DEPARTMENT OF ENVIRONMENTAL PROTECTION  
BUREAU OF HAZARDOUS MATERIALS AND SOLID WASTE CONTROL

M E M O R A N D U M

RE: Draft EE/CA Building 95 BNAS, August 1992

<b>AIBB</b> ABB <small>ASEA BROWN BOVERI</small> Environmental Services Inc.	BUILDING 95 AREA 0'-1' BELOW GROUND SURFACE EXCEEDING PRELIMINARY REMEDIATION GOALS	
	BUILDING 95 EE/CA	
INSTALLATION RESTORATION PROGRAM NAVAL AIR STATION BRUNSWICK, MAINE	7122-02	FIGURE 2-1

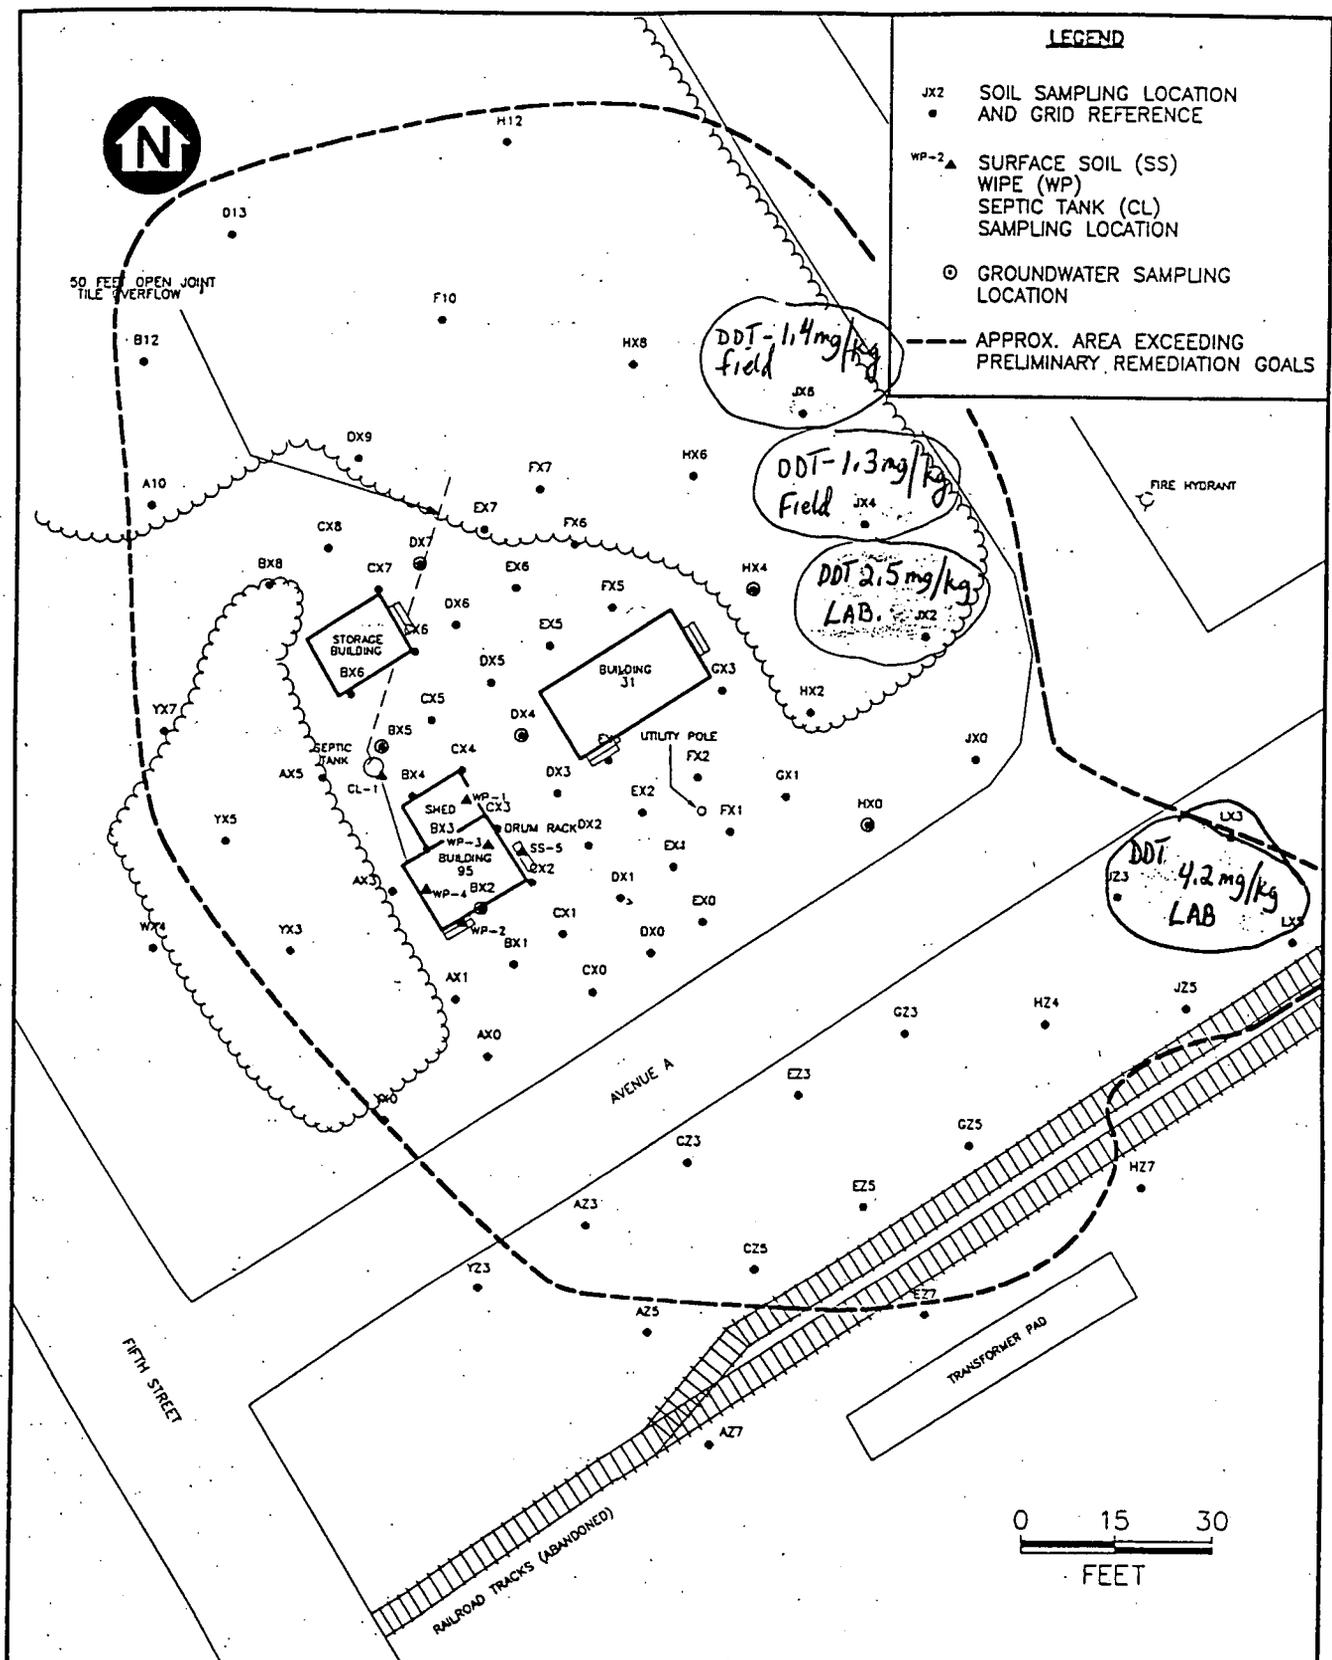
Pg 2-85 Figures 2-1 and 2-2 reportedly delineate soils exceeding the Preliminary Remediation Goals at 0-1 ft and 1-2 ft bgs, respectively. However, field and laboratory data indicate contamination at 0-1 ft bgs may extend beyond LX3 and JX2. Consequently, additional confirmatory samples may be needed east of the unnamed road to firmly establish the eastern limits of soil removal (see modified Figure 2-1 attached).
